United States Cold Storage

Date: 11/20/23 Report No.: 233-23

Type of Inspection:

Visual Inspection (VT) of welded joints per AWS D1.1-2020 Structural Welding Code - Steel, Clause 8, Table 8.1 and Drawings supplied by Stellar Construction.

Plate washers not welded along Line 23

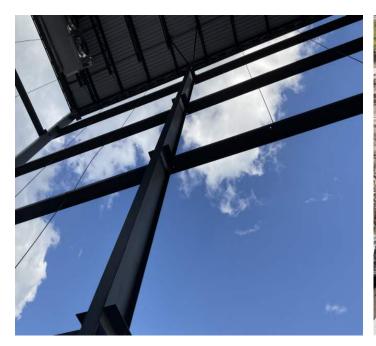
- Tighten column base plate anchors. These are loose in several locations
- Weld plate washers at braced frame locations along Line 23
- Completion of TC bolts at braced frame connections
- Weld girder stabilizer plates at braced frames
- Marr threads on Sag Rods per Detail2/E301A
- RFI for welded connection opposed to slotted connection at 23/K5
